Informal document **GRE-80-0x**  
(80<sup>h</sup> GRE, 23-26 October 2018,  
agenda item n(a))

**Task Force  
on Electro-Magnetic Compatibility  
(TF EMC)**

**Status report to GRE-80**  
**xday, xx. October 2018**

# TF EMC Status Report

### Correction of figure x at Annex 9 – Appendix 3

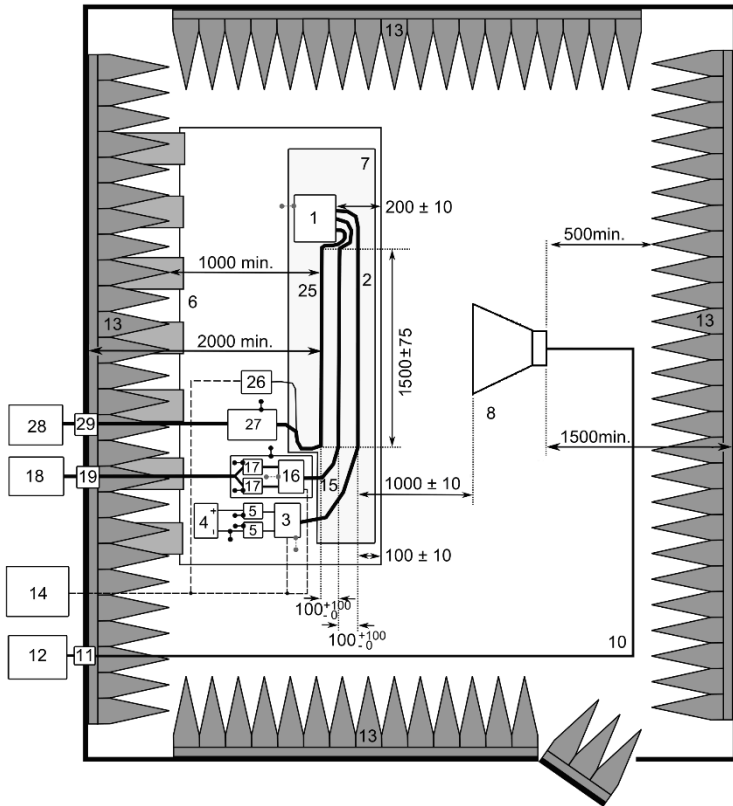
### Informal document submitted by OICA TF EMC

Top view (Vertical polarization)
